SERVICE BULLETIN

N° 139-670

ATA 11 – ADDITIONAL MARKING PLACARD INSTALLATION

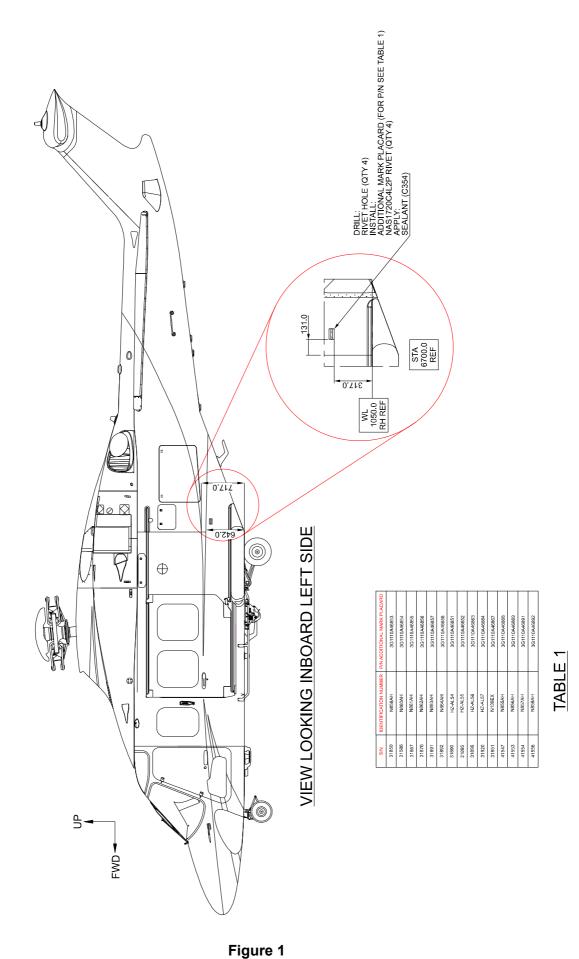
- 2. With reference to Figure 1, perform the additional mark placard installation as described in the following procedure:
 - 2.1 With reference to Figure 1 View Looking Inboard Left Side, temporarily locate the applicable additional mark placard and countermark position of n°4 rivet holes in accordance with dimensions shown.

- 2.2 With reference to Figure 1 View Looking Inboard Left Side, drill n°4 rivet holes thru the frame of the helicopter.
 - 2.3 With reference to Figure 1 View Looking Inboard Left Side and Table 1, install the applicable additional mark placard by means n°4 rivets P/N NAS1720C4L2P and Sealant (C354).
